URGENT FIELD SAFETY NOTICE

GEHC Ref# 32047-2

RE: Infant Warmer System (IWS) Hot "Heater Head" Screw could Fall onto the bed

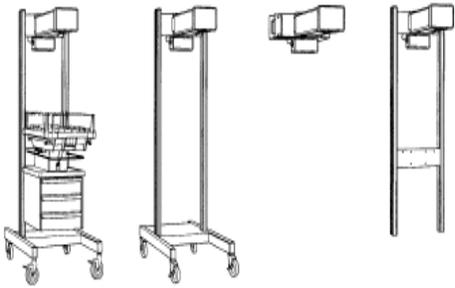
Hot screws from the "Heater Head" of the IWS could fall onto the bed if the "Heater Head" assembly has been improperly serviced. This situation can be clinically hazardous because thermal injury to a patient could result. Two injuries have been reported as a result of this issue.

As a result, if "Heater Head" service has been performed in the past, check to ensure that the screws are tightened as soon as the unit becomes available.

If the "Heater Head" assembly has not been serviced, check to ensure that the screws are tightened as part of your next regularly scheduled annual Preventive Maintenance check.

The attached Service Manual Addendum provides instructions for checking and tightening the screws. During each annual Preventive Maintenance check, continue to ensure that the screws are tight.
